Re: St. Lucie Plant Unit 1
Docket No. 50-335
Renewed Facility Operating License No. DPR-67

Response To Request For Additional Information Identified During Audit Of The Safety
Analyses Calculations for the Extended Power Uprate License Amendment Request

RESPONSE TO REQUEST FOR ADDITIONAL INFORMATION IDENTIFIED DURING AUDIT OF THE SAFETY ANALYSES CALCULATIONS

Feedwater Line Break (FWLB)

The sequence of events and selected graphical results are provided below in Table 4-1, Table 4-2, and Figures 4-1 through 4-12. Table 4-3 provides a summary of the analysis.

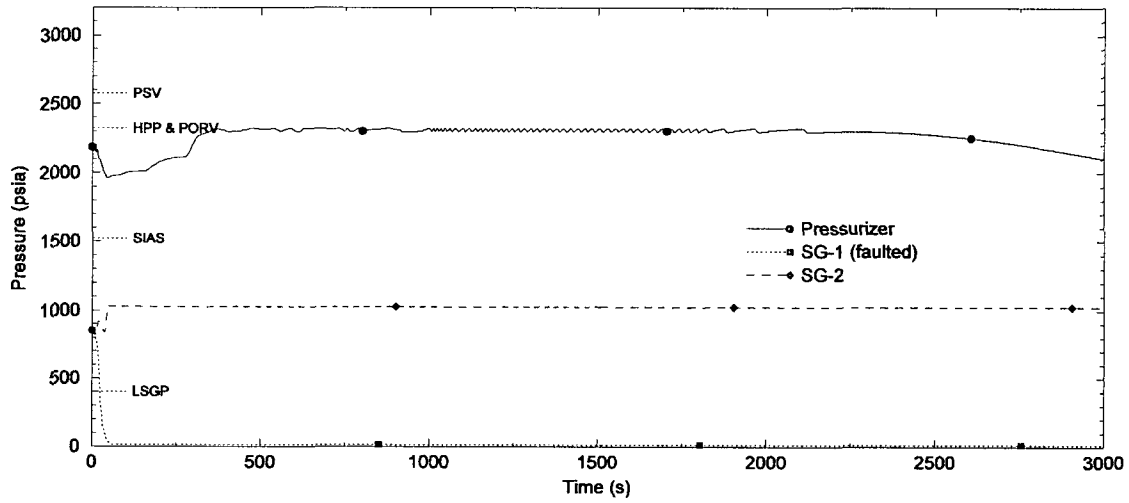
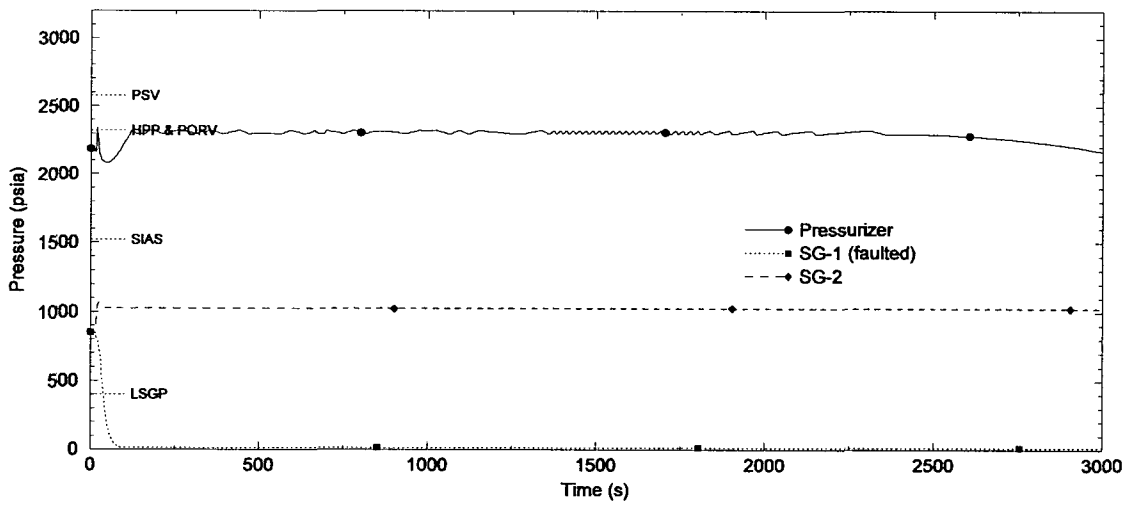
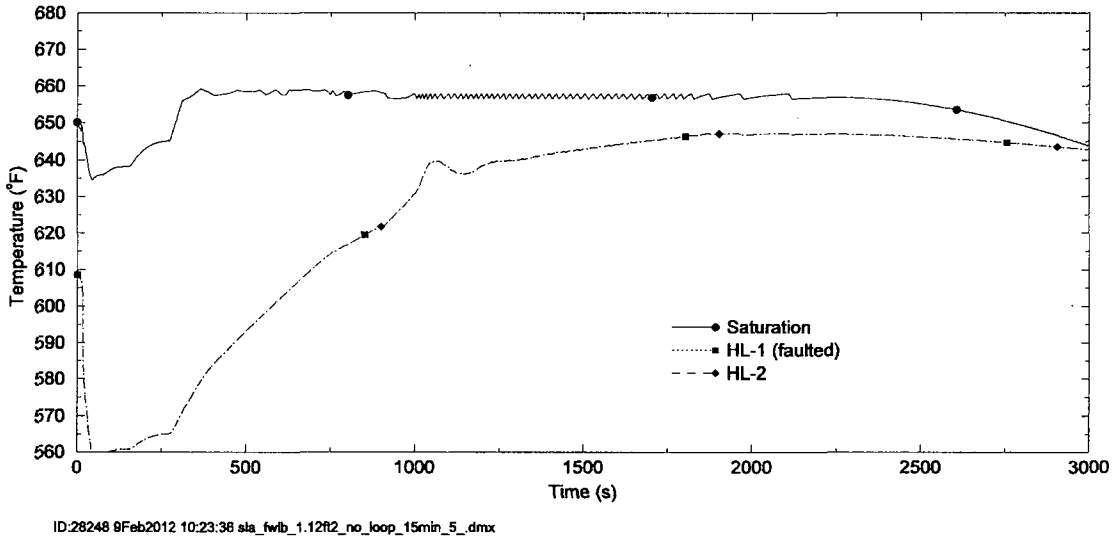
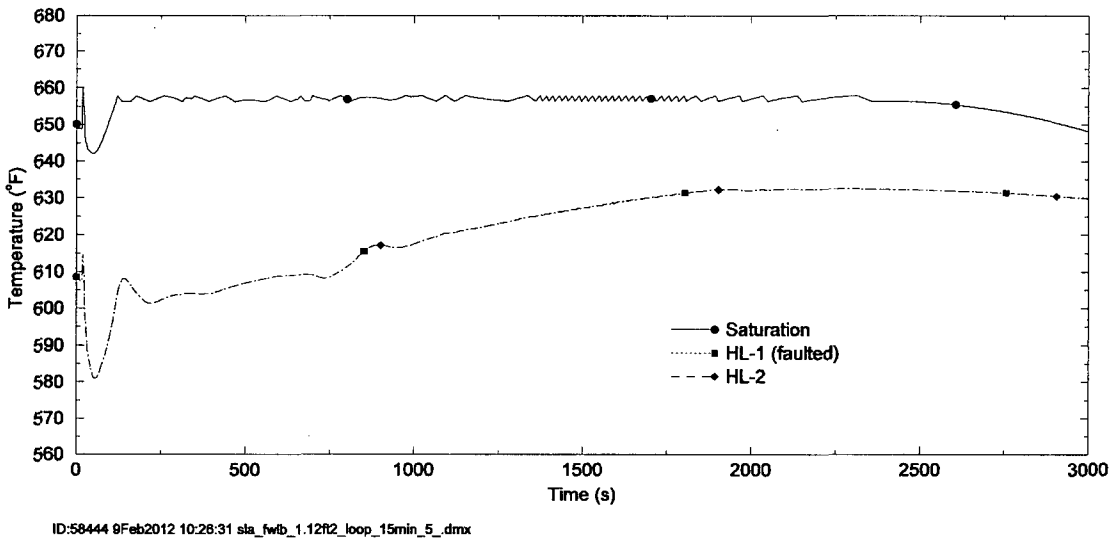
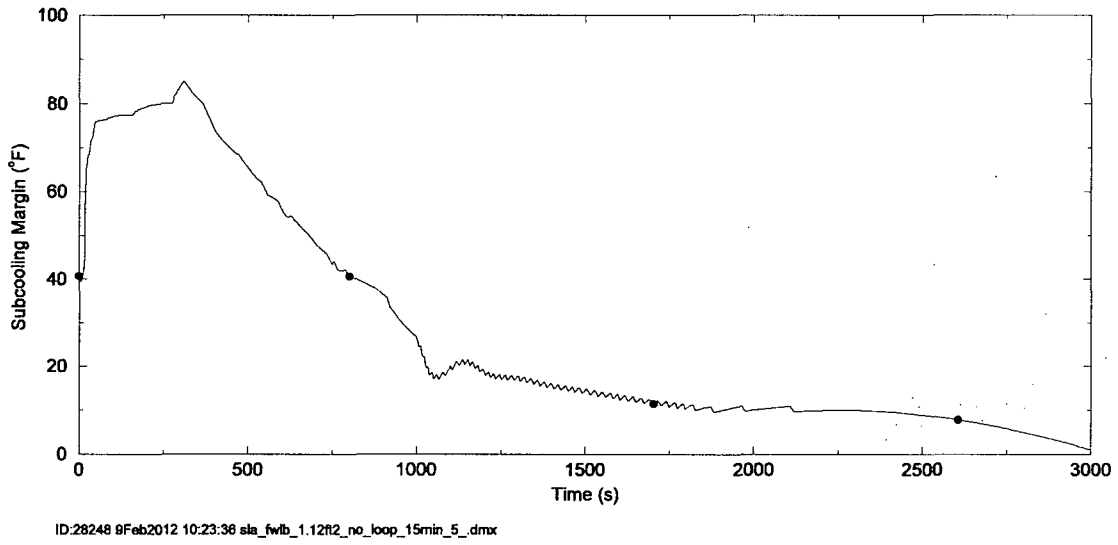
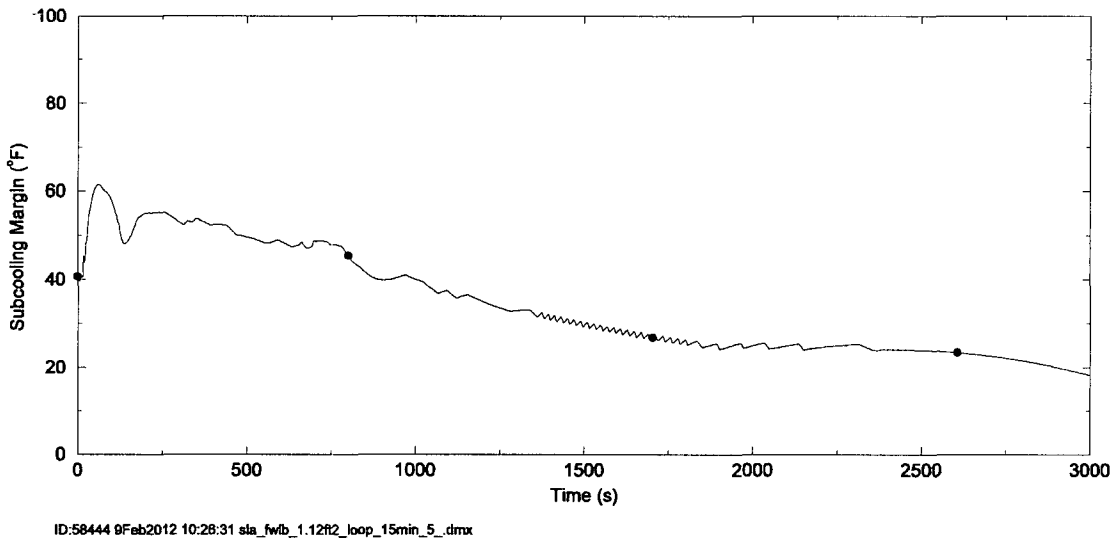
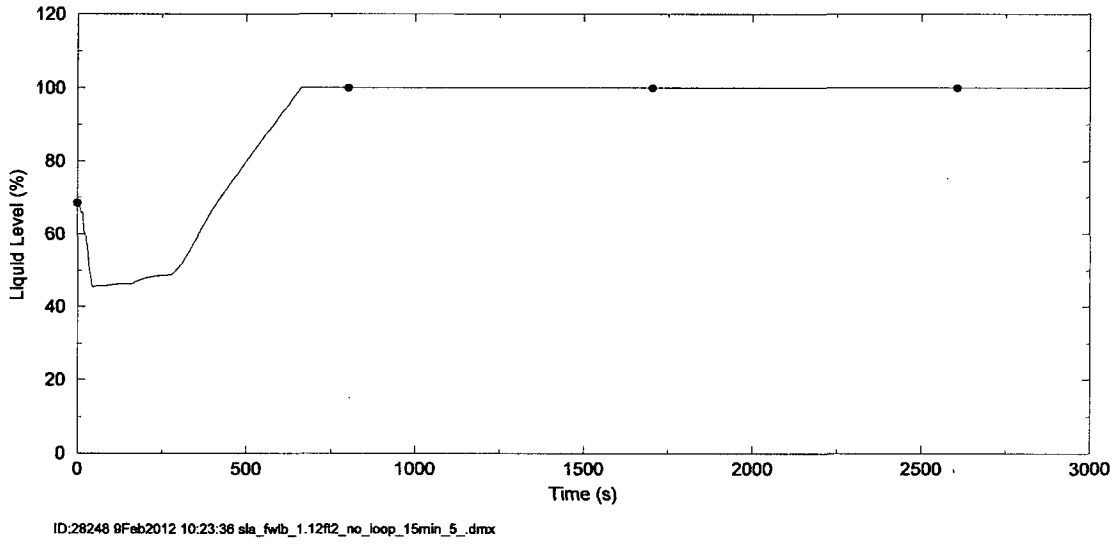
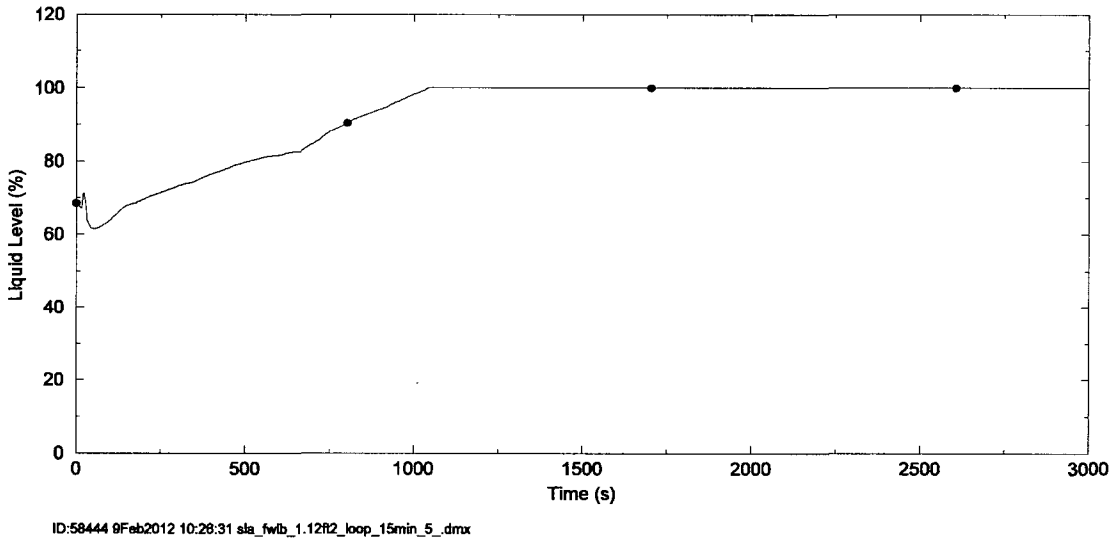
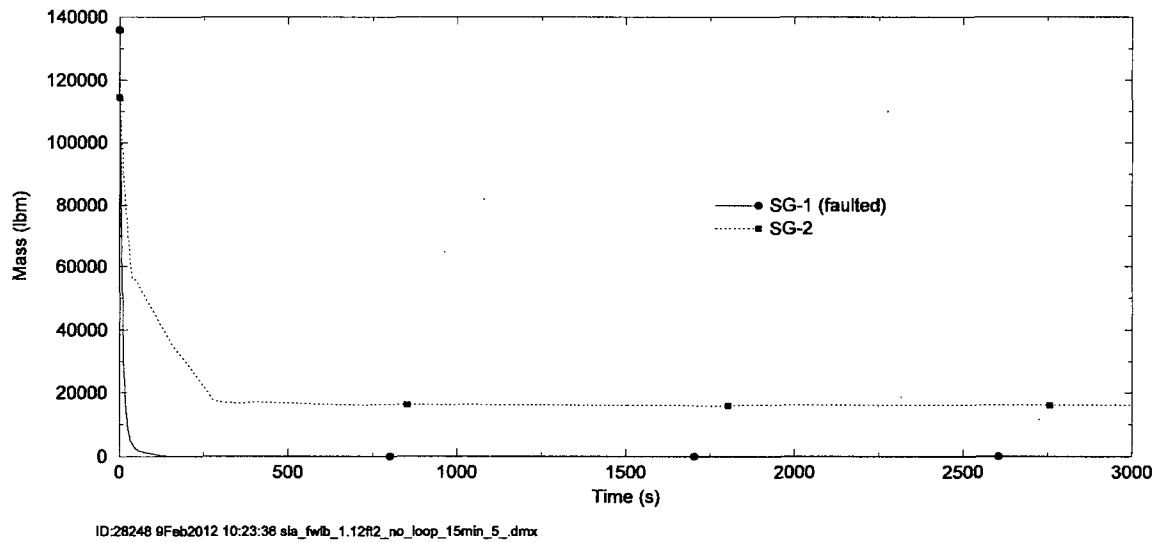
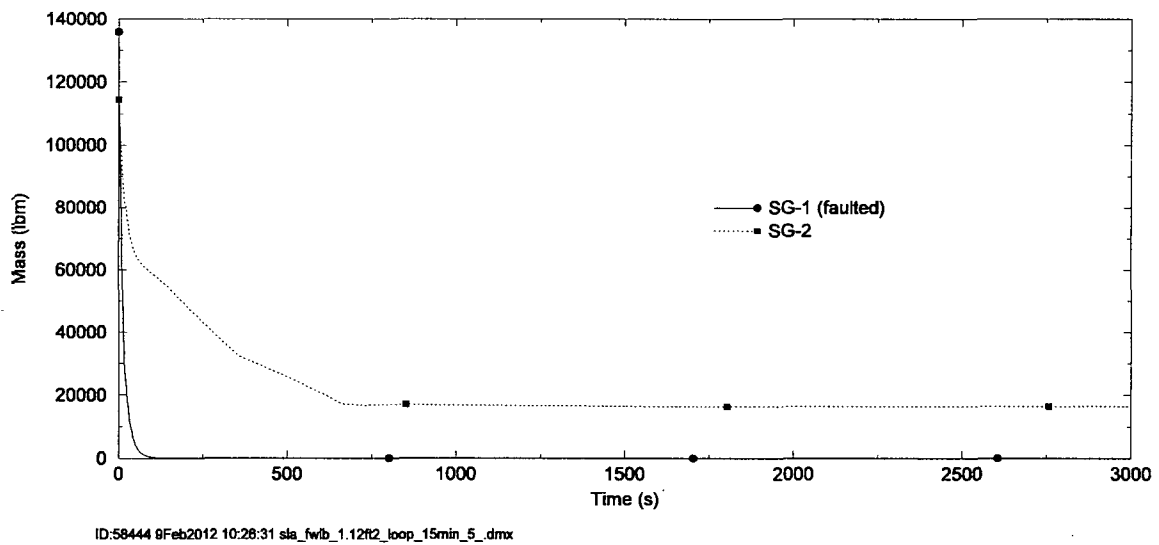
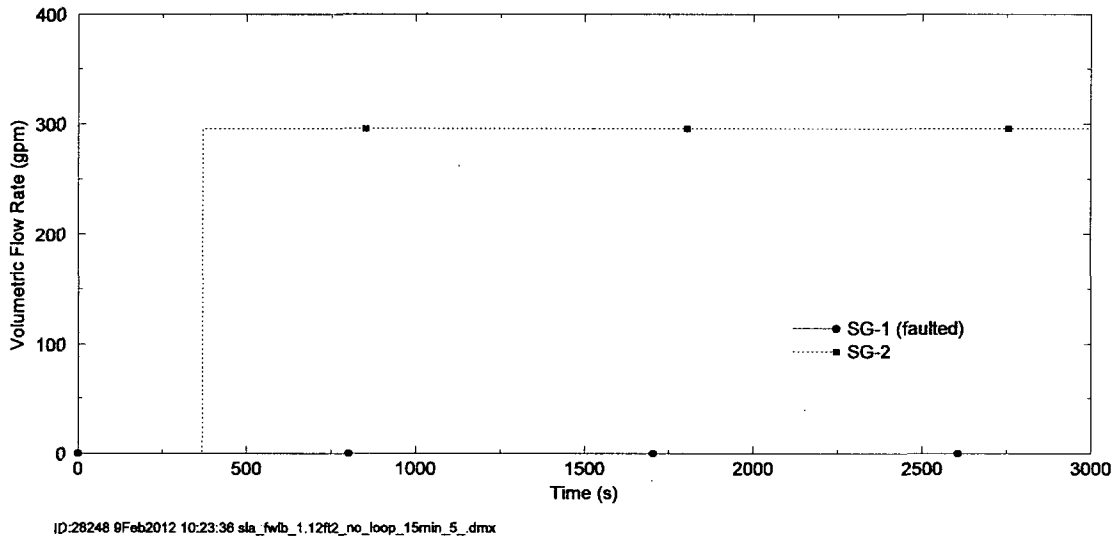
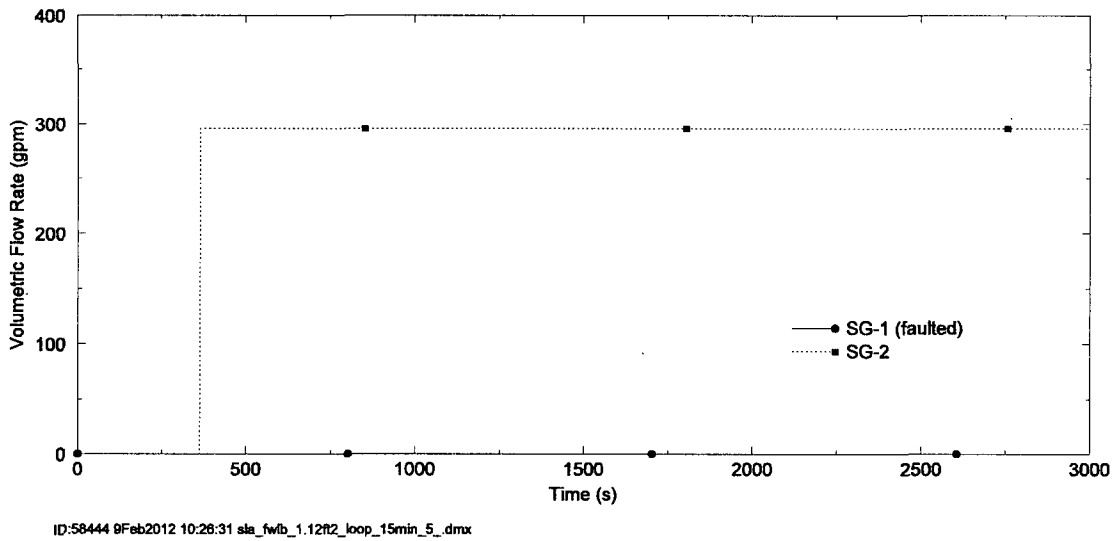
Submit a feedwater line break (FWLB) heatup analysis. Provide one case with offsite power available and one case without offsite power available.

This evaluation demonstrates that a FWLB event, with input assumptions typical of the limiting analyzed case, affords adequate margin to hot leg saturation under EPU conditions. This information provides reasonable assurance that the consequences of a FWLB event do not present a safety concern for operation at EPU conditions.
